RE: Cottonwood Mall Site Traffic Study Review – Holladay, UT

The following is a review of the October 2017 Cottonwood Mall Redevelopment Traffic Impact Study Update from Hales Engineering. The purpose of the review is to identify if the methodology is appropriate for the standard practice and that there is concurrence with the findings of impact and associated mitigation. The review items include the elements of the traffic study.

Traffic Study Review Comments

Conflict from the west and east center turn lane at Mall Access on Murray Holladay Road

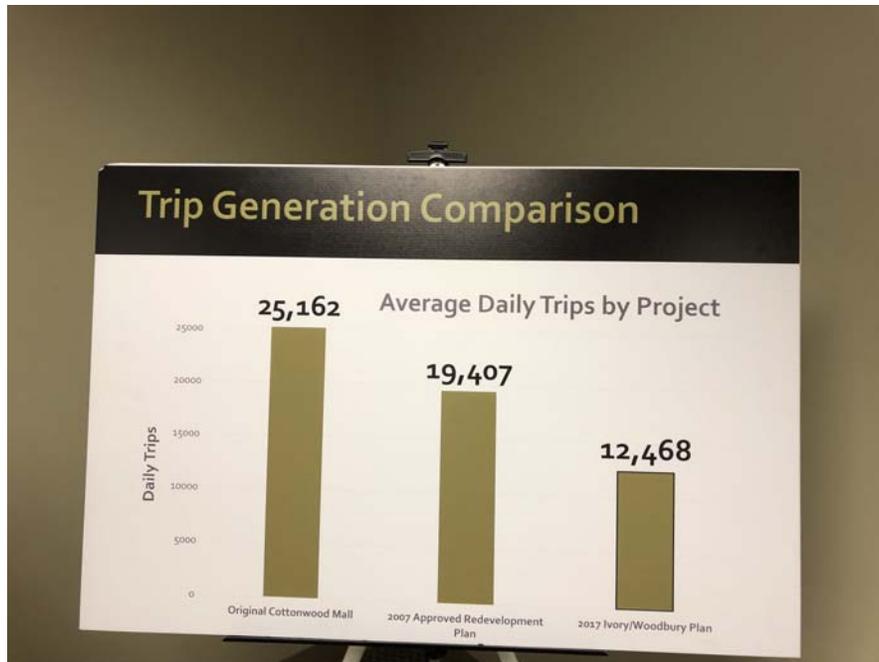
- The proposed site plan separates the site into two distinct parcel from a traffic aspect.
- No unsignalized access onto the Murray-Holladay is included in the analysis and therefore the assumption is this access will be closed. This is confirmed on page 11 under E. Access that states the only access on Murray Holladay Road will be located at the signalized intersection.

- If it were requested to remain open, it should only be considered as a right-in / right-out due to current operational issues for westbound queueing at Murray Holladay and eastbound left turn movements into the commercial area.
- A development this size should include an AM peak analysis. The trip generations shows that the larger egress from the site is in the AM peak and egress from the site is the likely critical issue.
- Memory Lane connection, other than as an emergency, should be analyzed if considered and a discussion as to why the residential homes could not be connected to the signal on Murray Holladay will need to be made.
- The connection at Arbor is too close to Highland and will likely lead to similar issues as on the west side of Highland at Meadowmoor.
- Is Meadowmoor going to continue to operate as a split phase. Meadowmoor signal needs to be completely rebuilt.

- IF requested, restrict Murray-Holladay unsignalized access to a right-in / right-out
- Construct the westbound right turn lane at Murray Holladay Road and Highland Drive. Ideally, the 4830 South traffic signal would have been located to a mid-block location to serve the property to the west as well as the Holladay Mall site.
- Reconstruct Meadowmoor / Highland Signal
- I would not recommend the relocation of Meadowmoor traffic signal to Arbor/Moormont under the current site plan and current signal location at 4830 South.
- The City has recommended that the original area of analysis be considered in this traffic study. The following is the existing conditions for the intersections analyzed.
